**SECTION 16 APPLICATION
TOWN PLANNING ORDINANCE (CHAPTER 131)**

PROPOSED SOCIAL WELFARE FACILITY (RESIDENTIAL CARE HOME FOR PERSONS WITH DISABILITIES) IN "VILLAGE TYPE DEVELOPMENT" ZONE ON APPROVED NAM SANG WAI OUTLINE ZONING PLAN NO. S/YL-NSW/10 AT LOTS 3669 S.A RP (PART), 3669 S.B RP (PART), 3670 RP (PART) AND ADJOINING GOVERNMENT LAND IN D.D.104, NAM SANG WAI, YUEN LONG

Town Planning Application No. A/YL-NSW/348 - Submission of Further Information (9)

CONSOLIDATED PLANNING STATEMENT

Figure Title **THE WALKING PATH BETWEEN THE PROPOSED RCHD AND THE NEARBY FRANCHISED BUS STOPS**

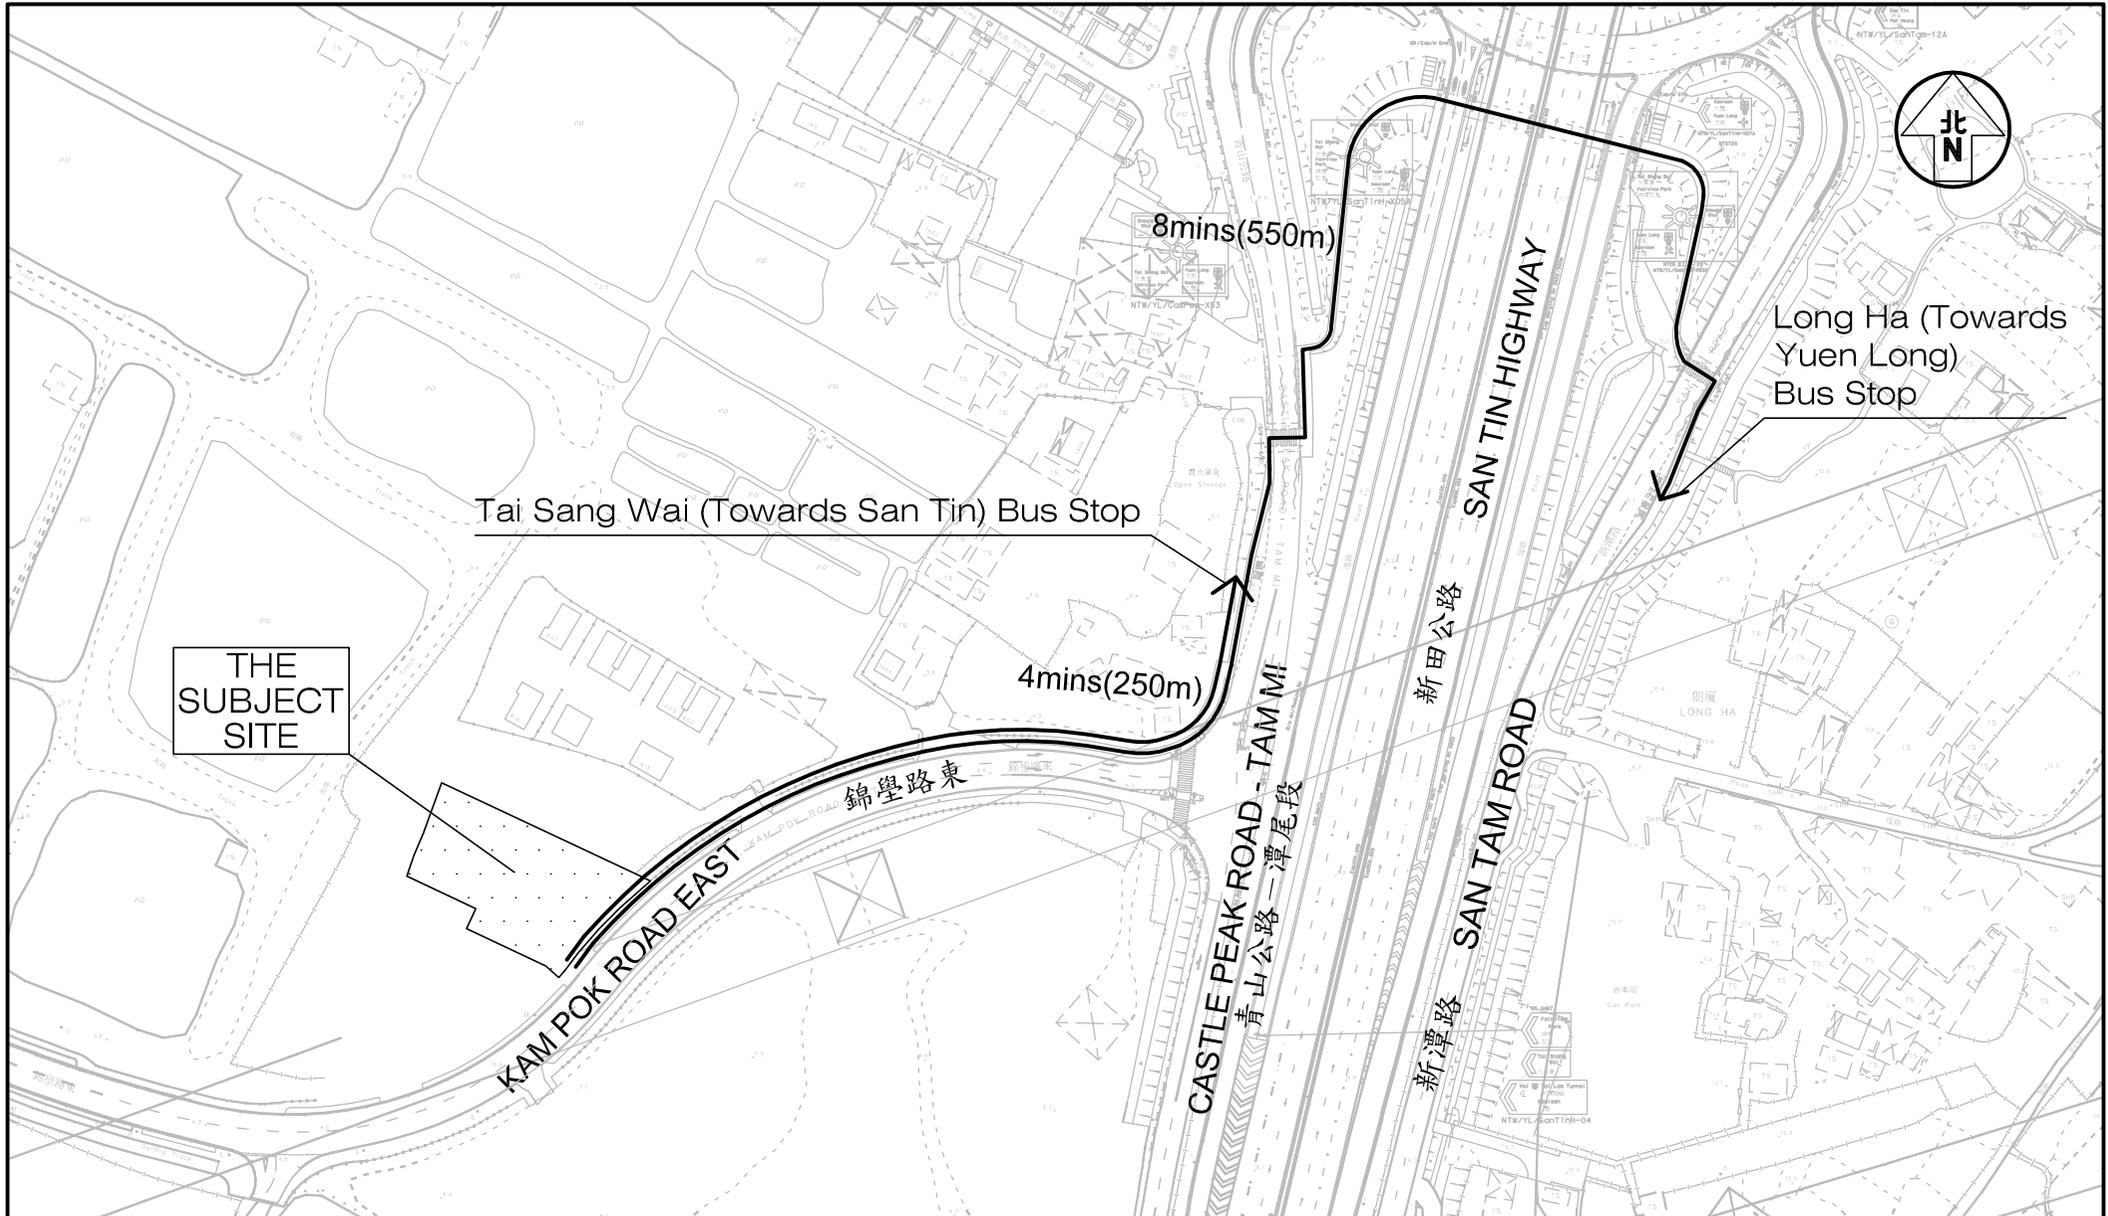
12. Please provide a plan showing the pedestrian routing to the nearby franchised bus stop (both Yuen Long and Sheung Shui bound). Please specify the corresponding walking distance as well;	Noted. Please refer to Figure 2.7 in the revised TIA for the pedestrian route to the nearby franchised bus stops.

Figure No. 3.3 Revision A

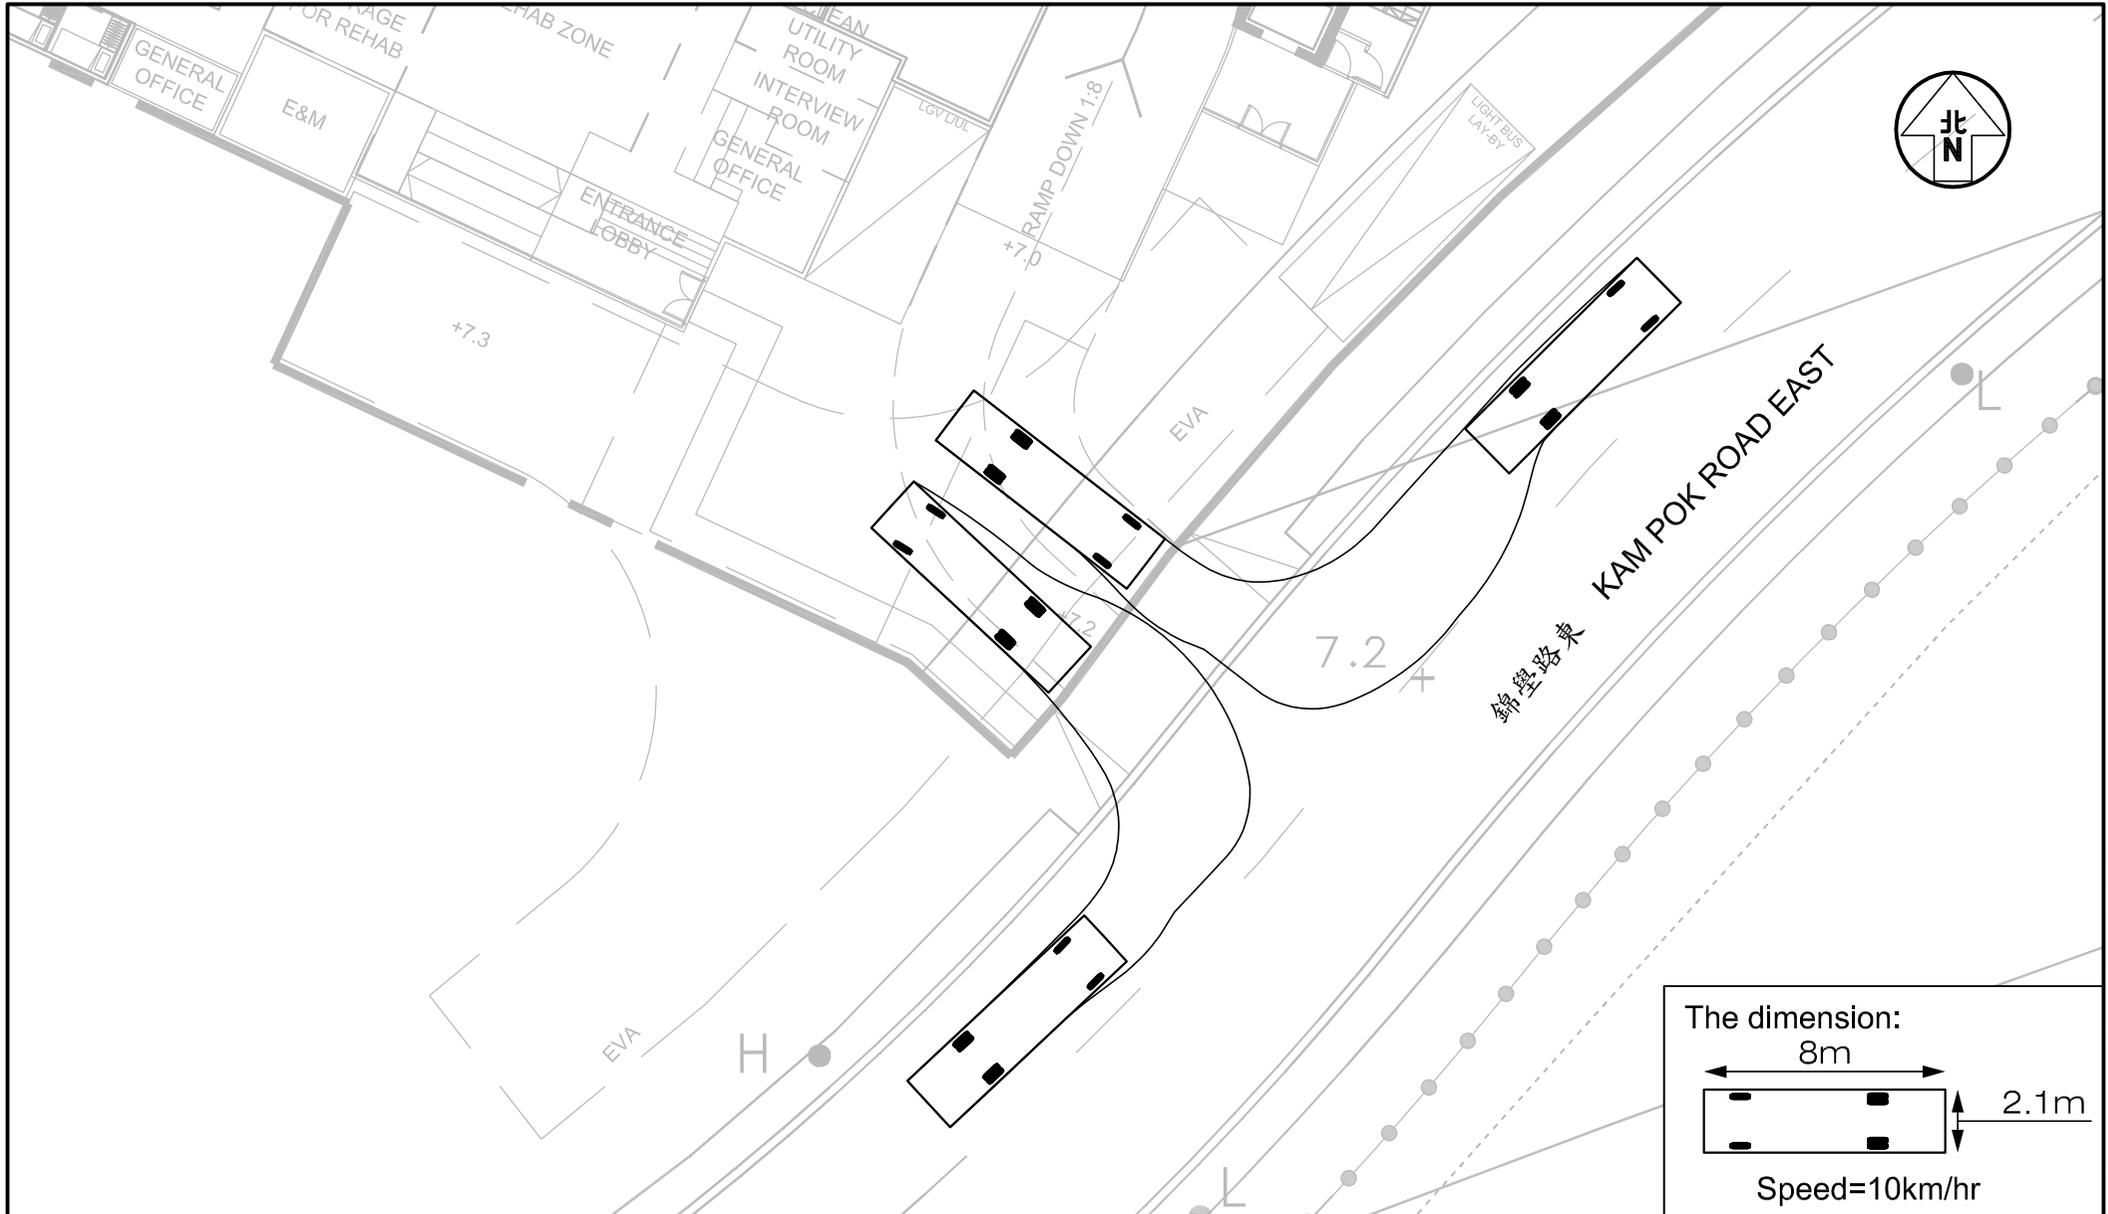
15. Please provide a plan to demonstrate sufficient sightline could be maintained at the proposed site access;	The measured length of visibility splay for the motorists leaving the Proposed RCHD is 60m to the left and 60m to the right, which is illustrated in Figure 3.3 in the revised TIA.

Noted. Please refer to the **Figure 3.3** in the revised TIA. The measured length of visibility splay for the motorists leaving the Proposed RCHD is 60m to the left and 60m to the right, so adequate sight line can be provided at the ingress/egress. The

FIGURE 2.1
LOCATION OF REPRESENTATIVE AIR
SENSITIVE RECEIVERS

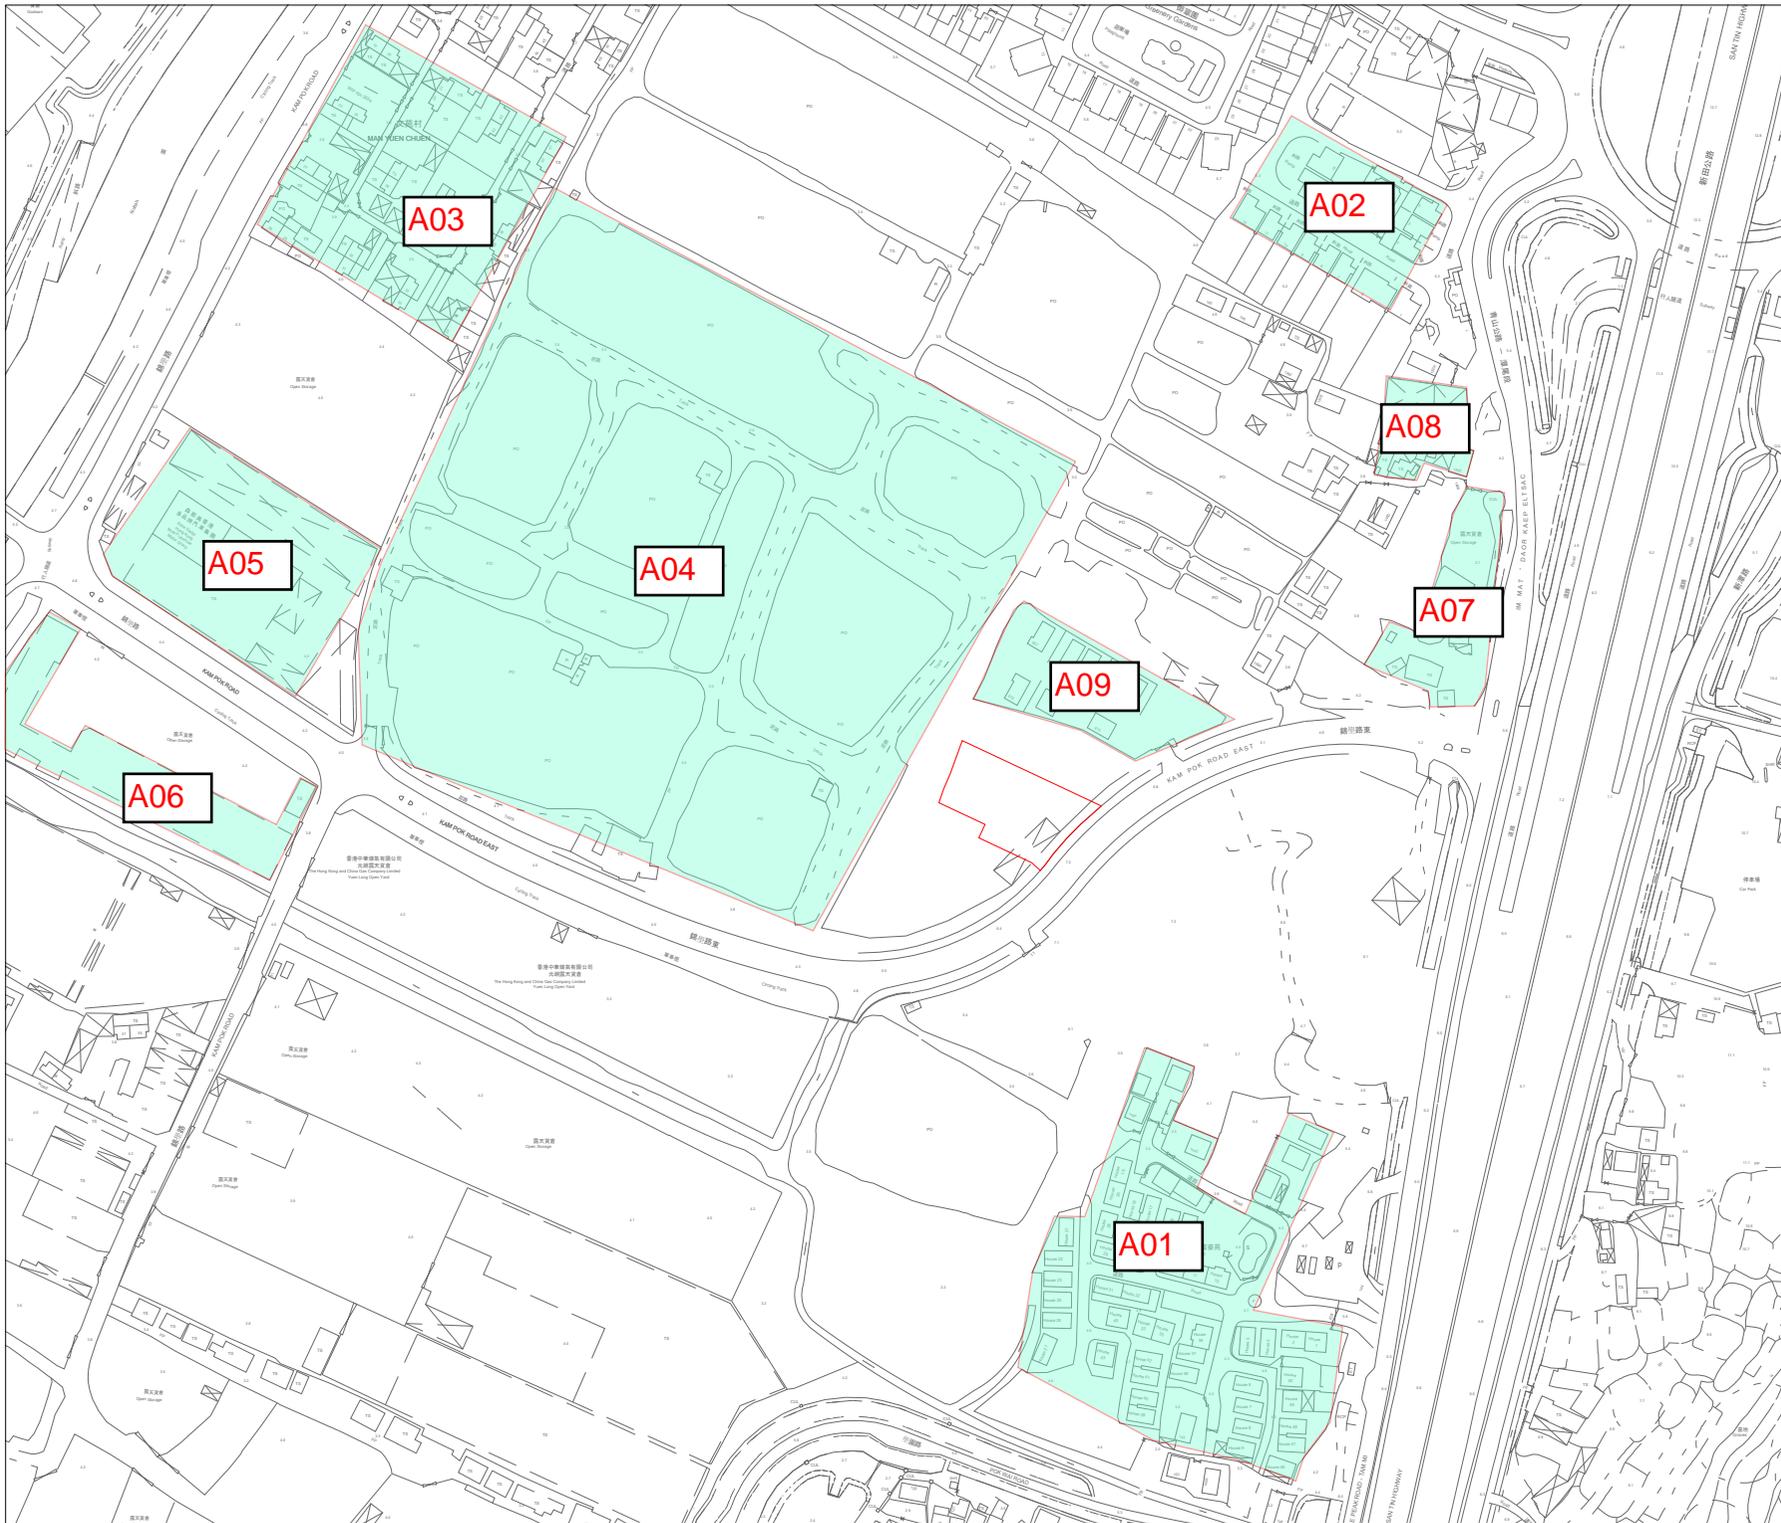
3. Section 2.3.1, Table 2.3 and Figure 2.1	
a. Section 2.3.1, Table 2.3 and Figure 2.1 - Please note that not only the domestic premises are the ASRs, some places/premises such as factory and workshop may also be the ASRs. Based on the desktop review, there are some areas in the vicinity of the project site which have been used for workshops/open storage, etc. Please review the potential existing/planned ASRs within the assessment area with reference to the Determination of ASR under the EIAO-TM and update as appropriate.	More ASRs have been identified in Table 2.3 and Figure 2.1. For other areas mainly for open storage use where long duration of exposure to air pollutants is not expected are, therefore, not considered as ASR.
